GROUP	MODEL
ENG	2024-2025MY Multiple Models w/ 2.5GDI or 2.5T-GDI Theta III Engines
NUMBER	DATE
264	March 2026

TECHNICAL SERVICE BULLETIN

CUSTOMER ACTION: ECU LOGIC IMPROVEMENT FOR DTC P2B59F0 (CA2516)

UPGRADE EVENT Sportage (NQ5, NQ5a):

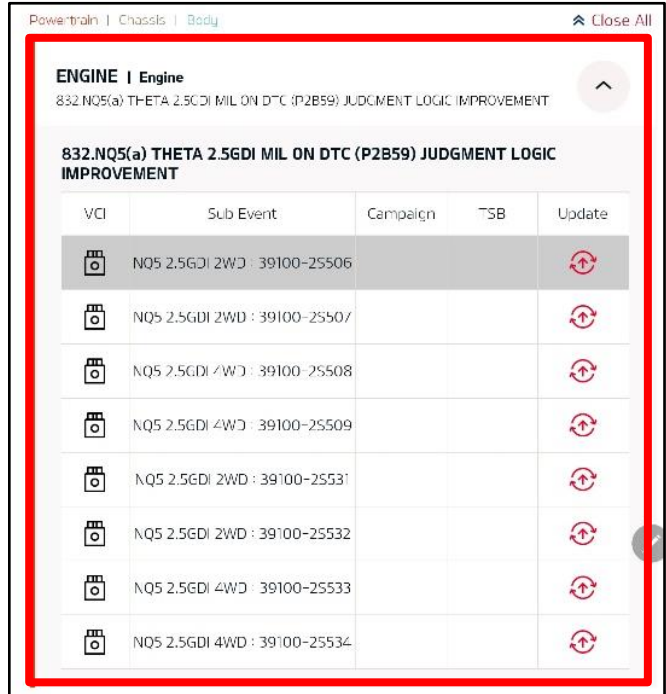
Select the applicable '832' system module and the Event Group.

- **832.NQ5(a) THETA 2.5GDI MIL ON DTC (P2B59) Judgement Logic Improvement**

Verify the affected vehicle Calibration Identification of the applicable ECU ROM ID and reference the Information Table on page 3 as necessary.

UPGRADE EVENT K5 (DL3):

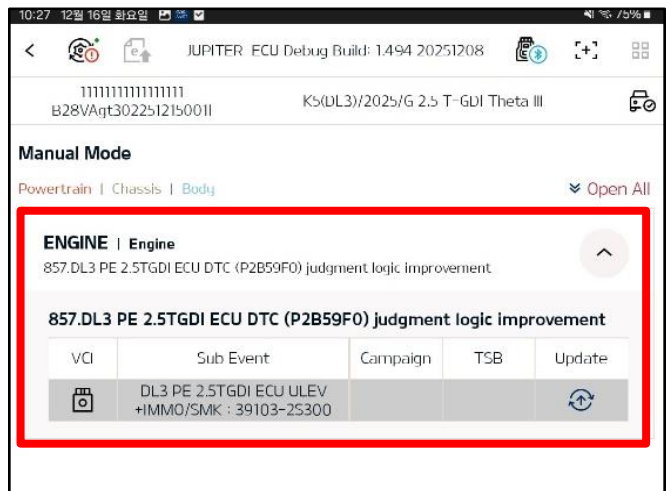
Select the applicable '857' system module and the Event Group.

- **857.DL3 PE 2.5TGDI ECU DTC (P2B59F0) Judgment Logic Improvement**

Verify the affected vehicle Calibration Identification of the applicable ECU ROM ID and reference the Information Table on page 3 as necessary.

UPGRADE EVENT Sorento (MQ4a):

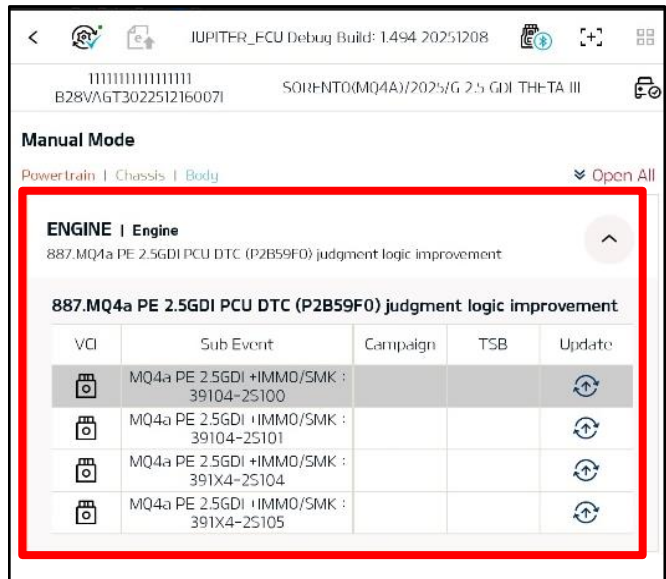
Select the applicable '887' system module and the Event Group.

- **887.MQ4a PE 2.5GDI PCU DTC (P2B59F0) Judgment Logic Improvement**

Verify the affected vehicle Calibration Identification of the applicable ECU ROM ID and reference the Information Table on page 3 as necessary.
